### ADDENDUM NO. 1 TO ALL BIDDERS/OFFERRORS:

Reference – IFB 2023-011

Description: Public Services Storage Building Renovations & Change of Use

Picture 1: Shows light gage metal closure panel cut around each bar joist.

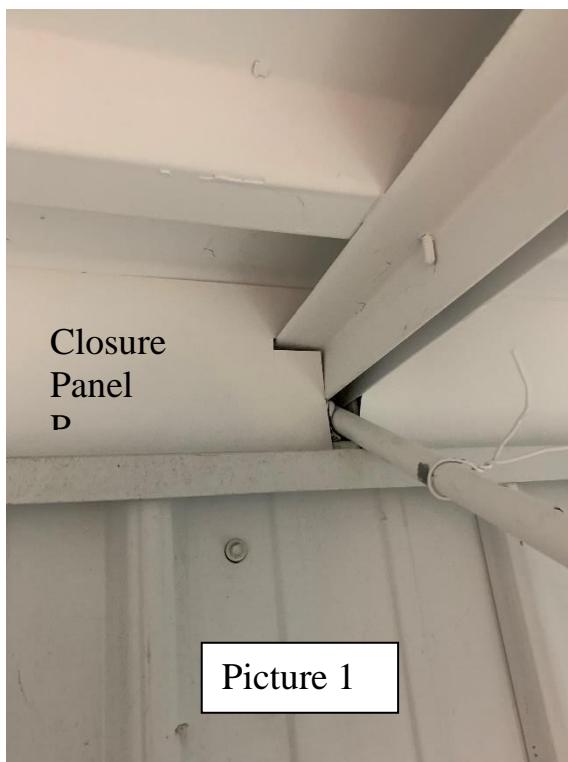
Wall Section 3/A2.1: At the head-of-wall condition, before "Fill entire void between top of existing concrete and under existing metal deck with Rock-Wool firestopping, stuff in opening all the way back to existing metal panels", there is a light gage metal closure panel and drip edge that appears to be screwed behind the metal wall panels by the top row of screws. Remove the screws and closure panel, but not the drip edge. Reinstall screws through metal wall panel but do not reinstall metal closure panel. Remove foam insulation sealant and the existing rigid insulation that is laid on top of the existing concrete wall between the bar joists before installing the Rock-Wool firestopping and Elastomeric sealant along entire length of fire barrier.

Picture 2: Shows rigid insulation and foam insulation sealant to be removed.

### RENOVATION PLAN KEY NOTES:

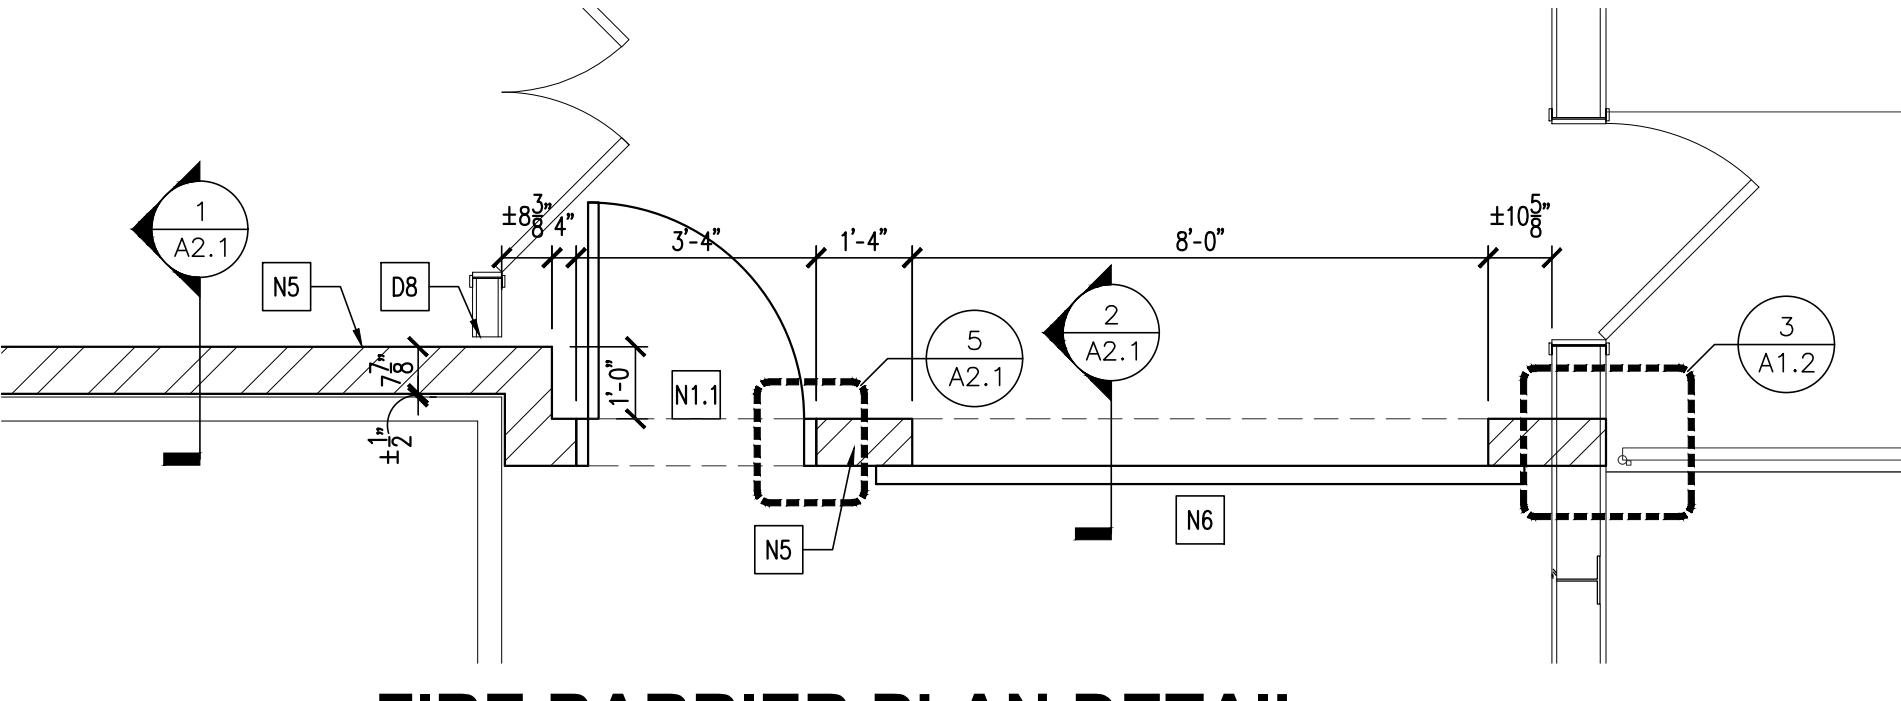
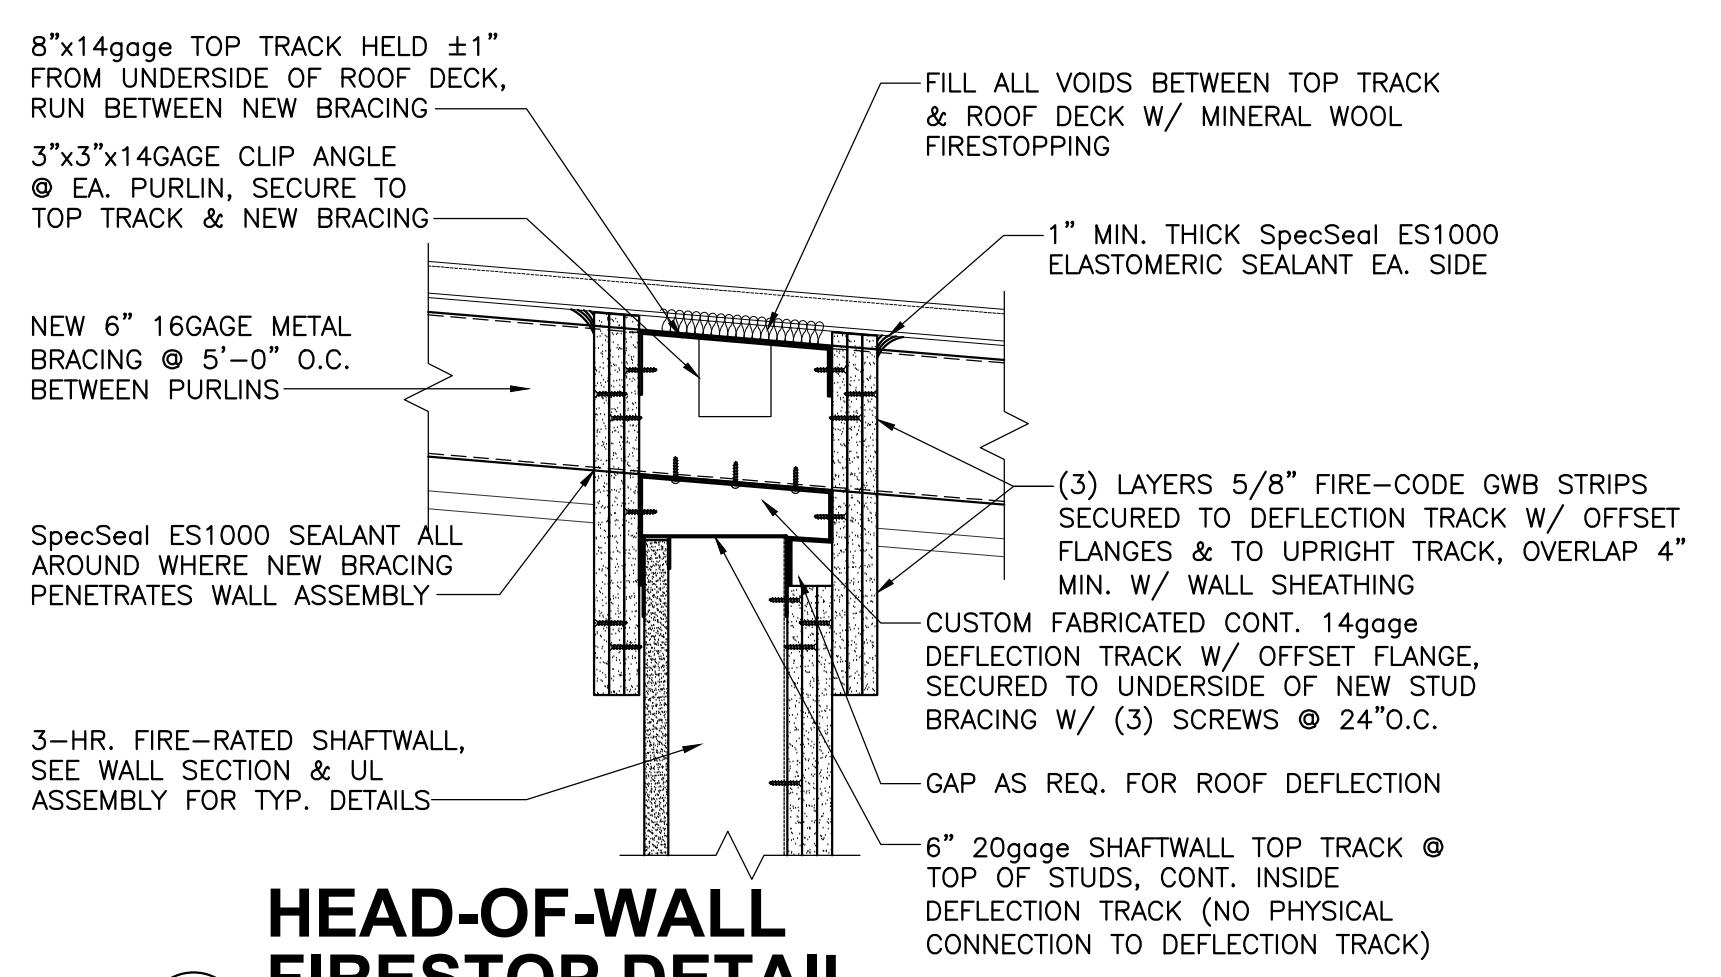
8. A 1.2, Note N9 (Options A&B)

- a. Note9 indicates options to "extend above lower roof", If lower roof is 11 ft, How far above the lower roof does Barrier Conversion extend?

- b. Option A would butt structural members, where there is not room between structure and CMU to place 1" shaft liner. Will the structural members need to be wrapped?  
*Option A has been omitted as an alternative. See revisions on sheet A1.2. Option B shall be the method used to convert the existing fire wall to a 3-hour fire barrier.*
- c. It is noted that the 3-hour barrier wall concrete does not extend to exterior wall of vehicle repairs building. (NIC)  
*See revised sheet A2.1, attached.*

*The Barrier Conversion needs to go up to the height of the lower roof.*

- 1 OPTION A: (OMITTED)
- 2 OPTION B: FILL ALL EMPTY CORES OF EXIST. 2-HR. CMU W/ "CORE-FILL 500" EXPANDING FOAM INSULATION, CONT. FROM FLOOR SLAB TO ABOVE LOW ROOF (SEE SHEET A2.3 FOR FIRE-RATING INFORMATION).

### WALL SECTION @ EXISTING FIRE BARRIER

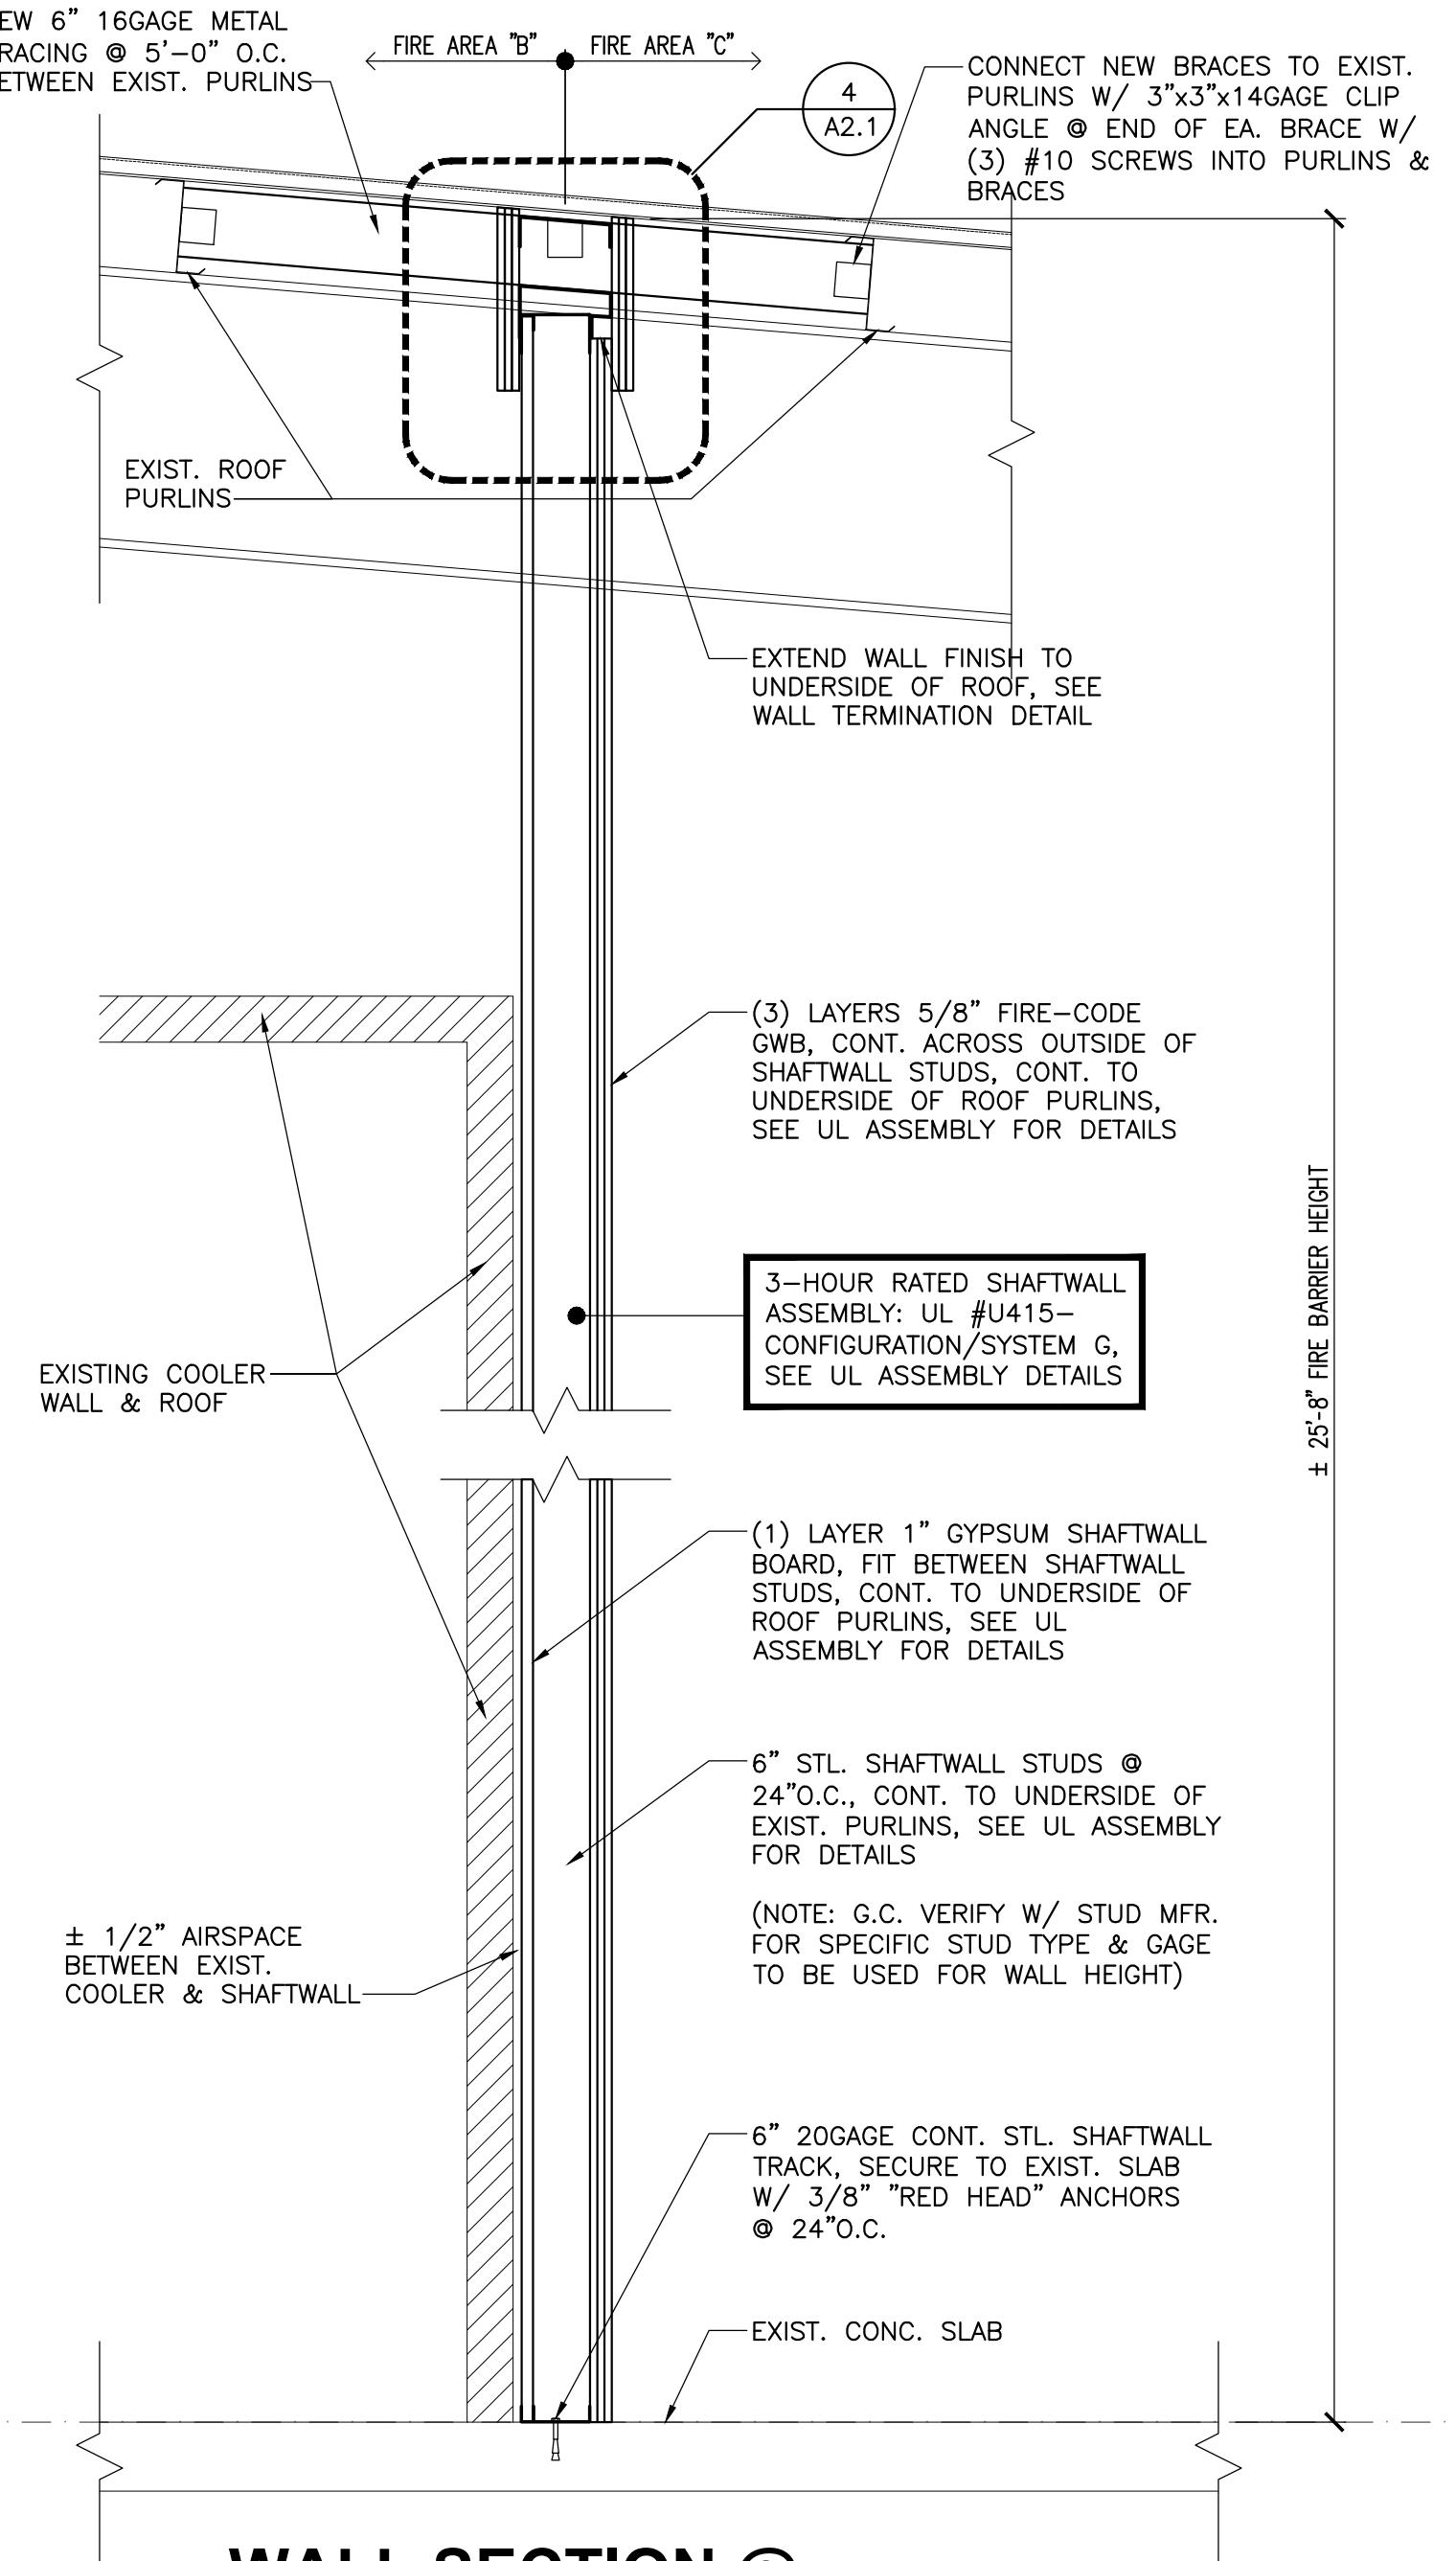
4. D1.1, Note 4, It is our understanding that the construction areas B & C (Site Key Plan on A1.1) will be unoccupied therefore not requiring Dust Barriers; however, area A will be occupied. Please provide further clarification of any dust barrier requirements in this area to perform scope in section 3/A2.1.

*No dust barriers are required.*

### WALL SECTION @ NEW FIRE COILING DOOR

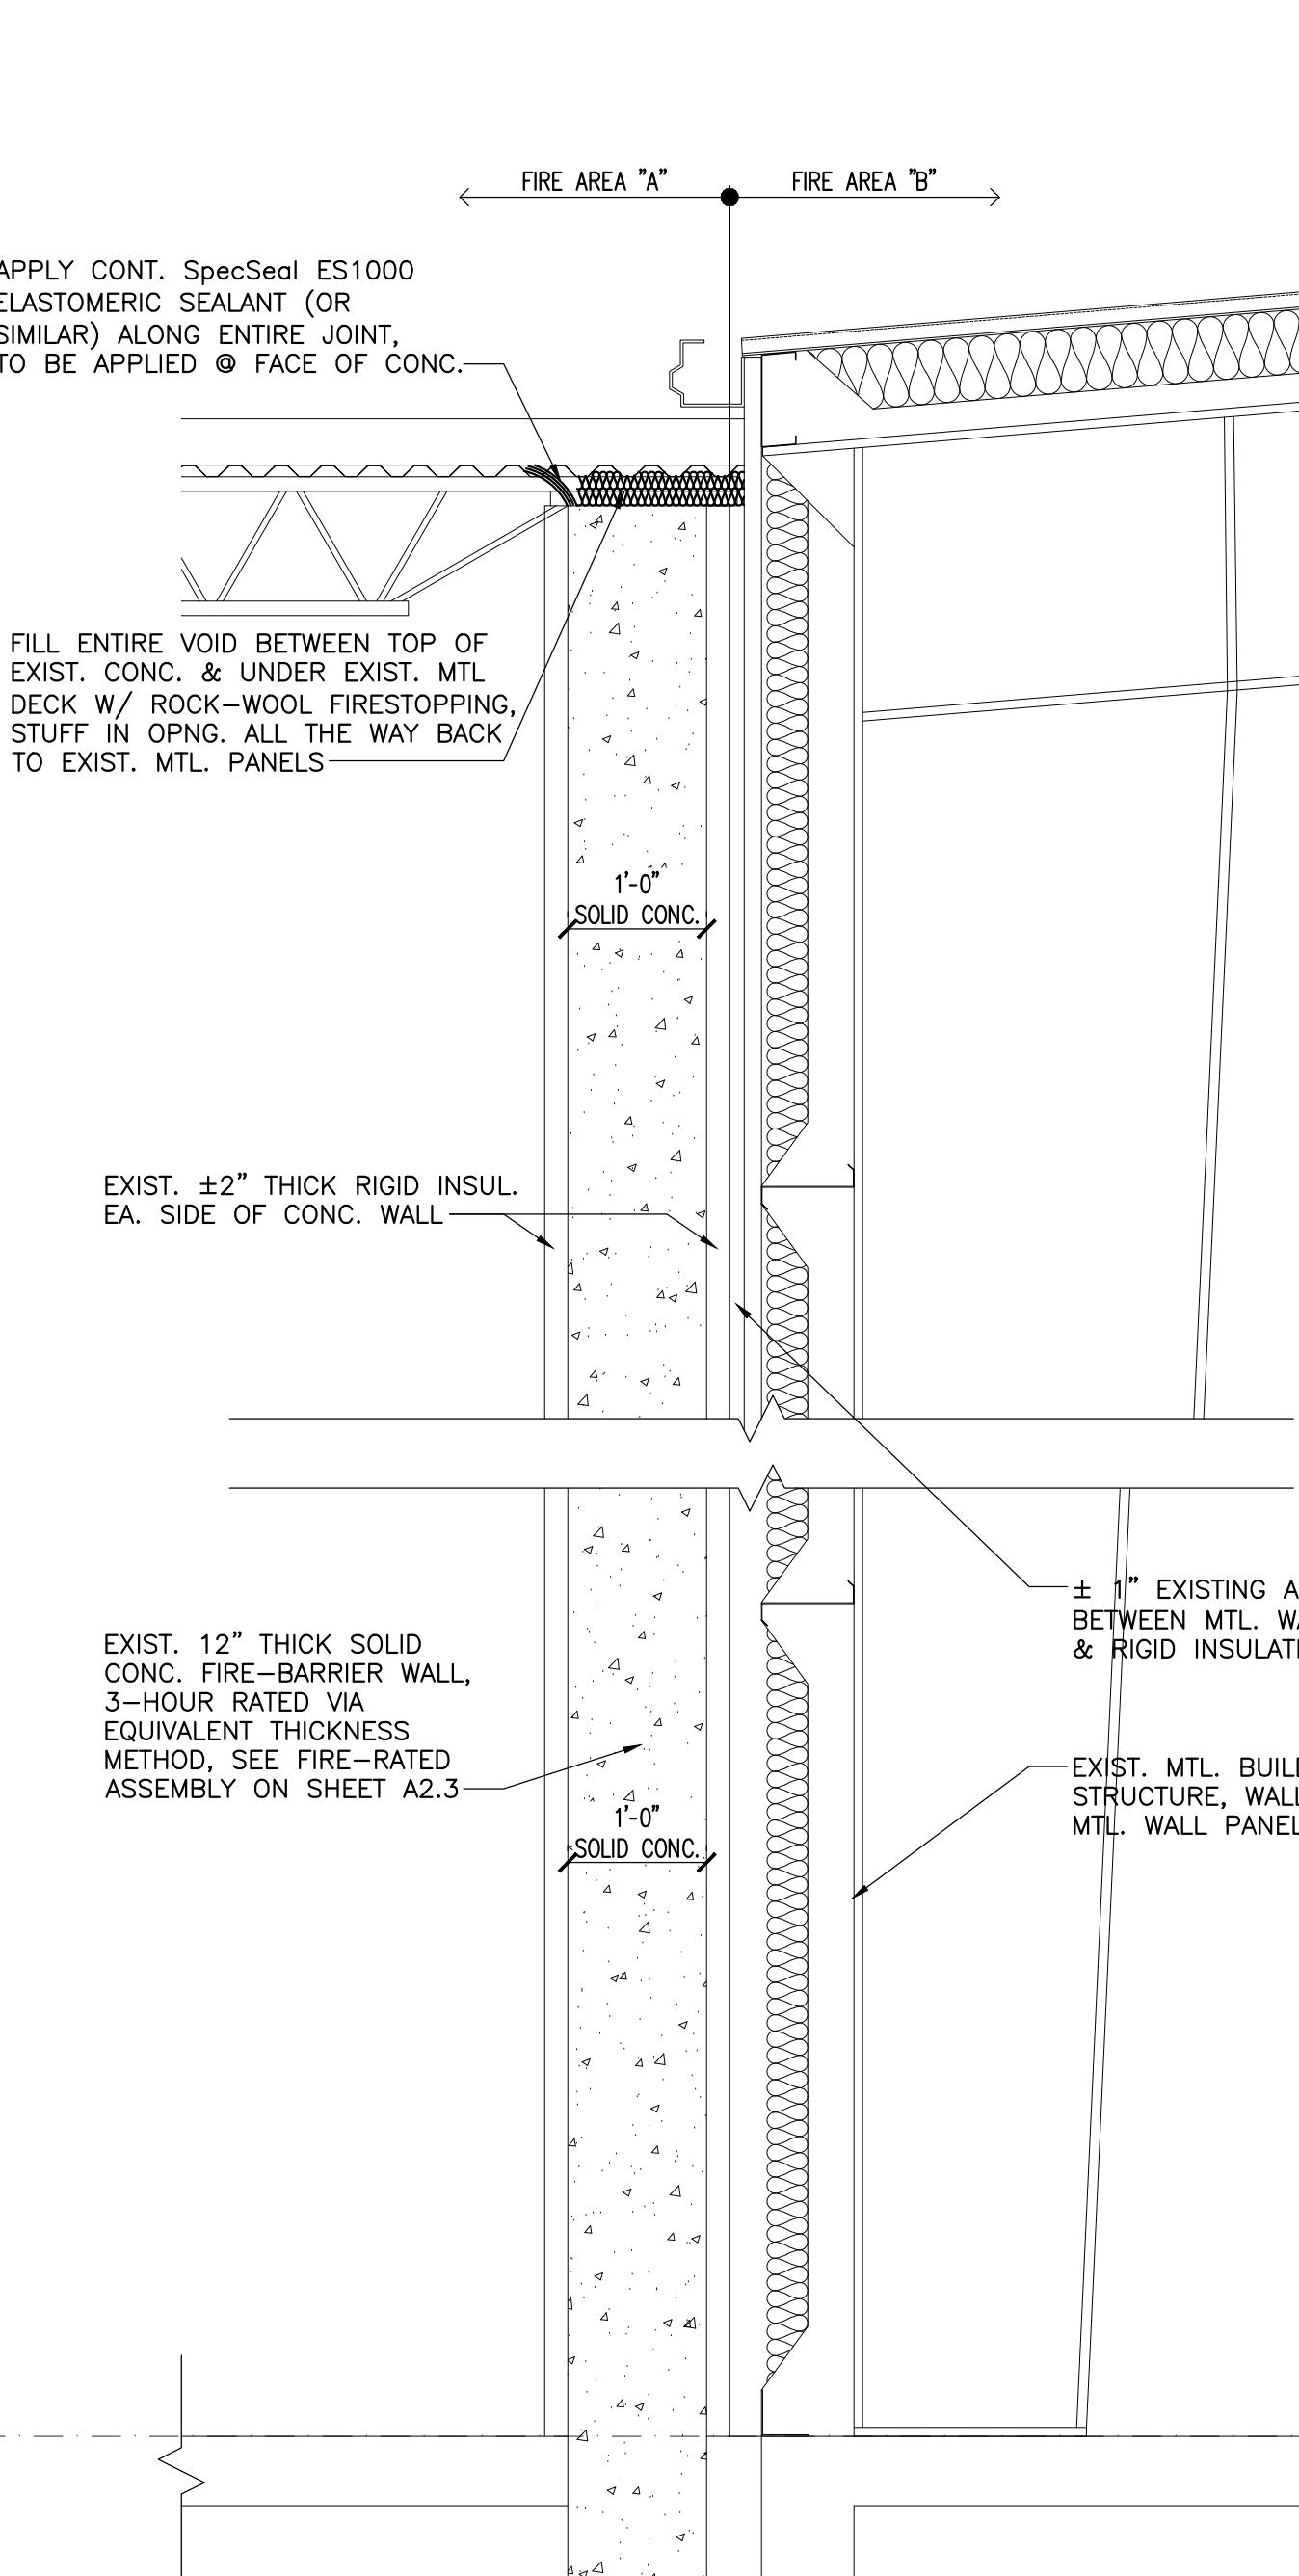
5. A1.2 Note N6 & N6.1, Overhead Coiling Doors (2/ A 2.1 ) notes indicate 18 gage metal stud jamb framing. Please confirm structural design, we believe minimally that 16 gage studs will be required for jamb framing to support the coiling doors.

*Contractors shall bid on the project as shown in the construction documents.*
